HISTORIC AND DESIGN REVIEW COMMISSION

April 03, 2019

HDRC CASE NO: 2019-160
ADDRESS: 126 ARMOUR
LEGAL DESCRIPTION: NCB 6203 BLK 4 LOT 7
ZONING: R-4, H
CITY COUNCIL DIST.: 1
DISTRICT: River Road Historic District
APPLICANT: Ian McNab Alicia Lovett
OWNER: Ian McNab Alicia Lovett
TYPE OF WORK: Landscaping/Xeriscaping front lawn
APPLICATION RECEIVED: March 22, 2019
60-DAY REVIEW: May 21, 2019
CASE MANAGER: Huy Pham
REQUEST:

126 Armour Place: Site Plan

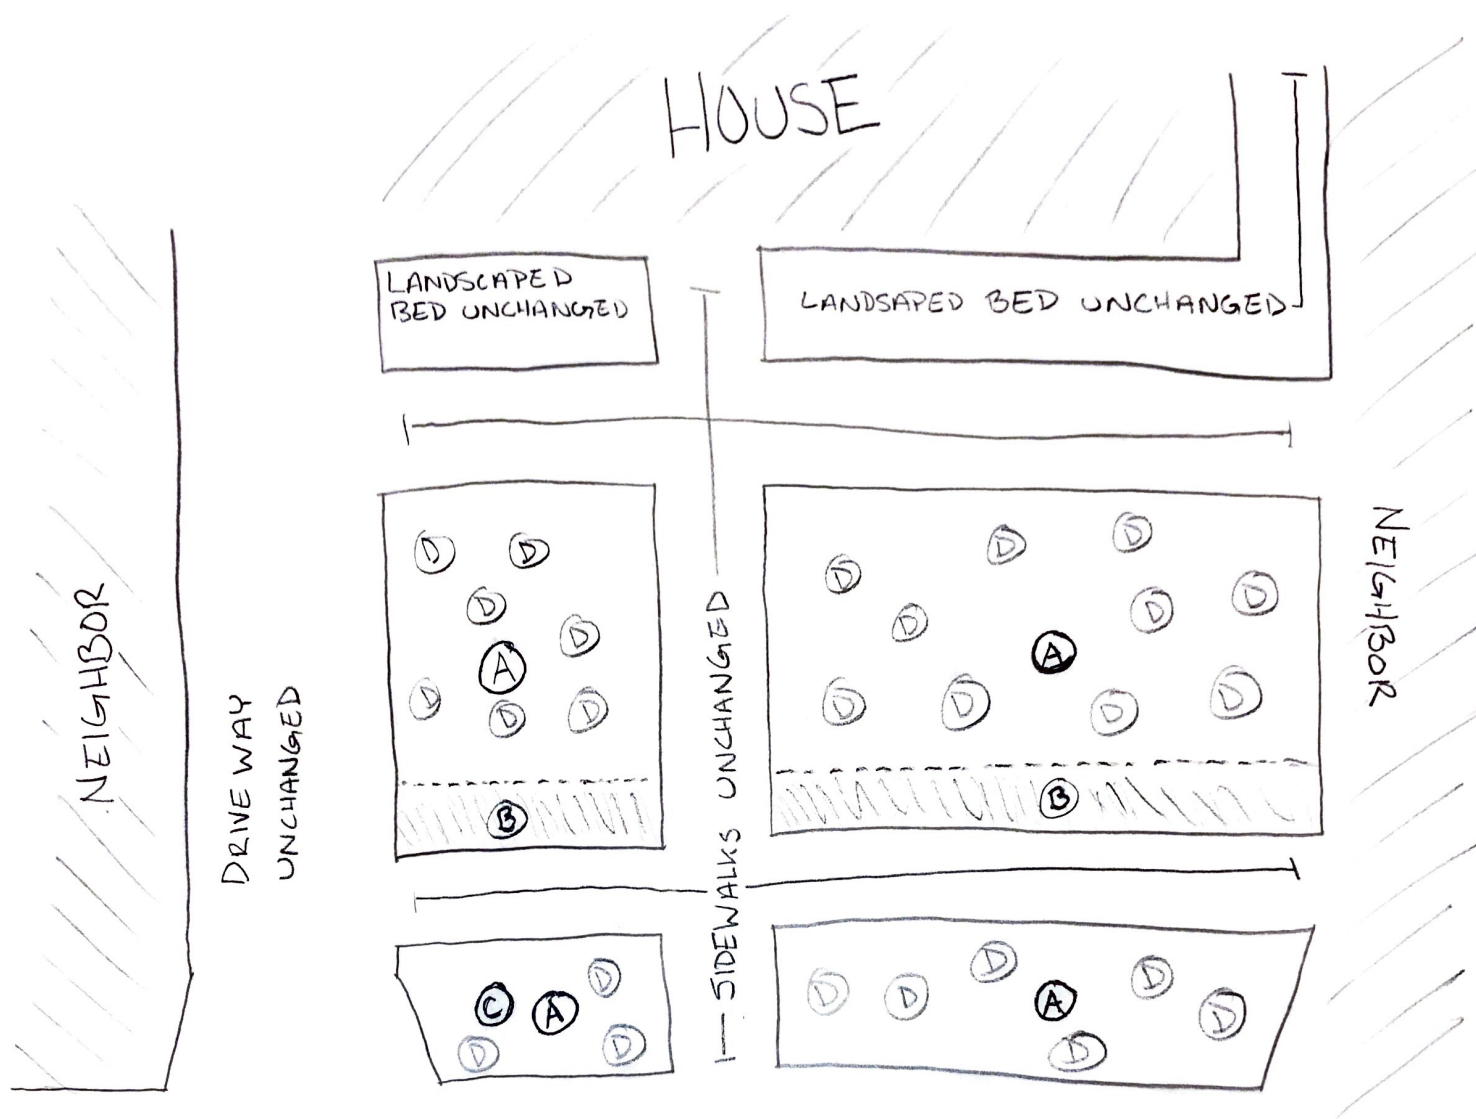
- c. NEW GRAVEL BEDS – The applicant has proposed to remove a majority of the natural turf, excluding the sloping portions along the sidewalk, and install crushed gravel beds with planting on top. Per the Guidelines for Site Elements 5.2.B.ii, new pervious hardscapes should be limited to areas that are not highly visible, and should not be used as wholesale replacement for plantings. If used, small plantings should be incorporated into the design. While the proposal includes large portions of lawn replacement with impervious cover, staff finds that the abundant inclusion of plantings mitigates the removal of lawn.

- d. NEW PLANTINGS – The applicant has proposed to install a variety of plantings including: santolina, red yucca, yucca, rock rose, agave, rose mary, and rosemary shrubbery. Per the Guidelines for Site Elements 5.3.A.iii and iv, plants should be selected to thrive in local conditions and reduce watering usage utilizing UDC Appendix E: San Antonio Recommended Plant List, and if a varied plant palette is used, incorporate species of taller heights, such informal elements should be restrained to small areas of the front yard or to the rear or side yard so as not to obstruct views of or otherwise distract from the historic structure. Staff finds that the selection and amount of plantings is generally appropriate and that additional low ground cover and xeric plants should be incorporated where feasible.

Staff recommends approval based on findings b through d.
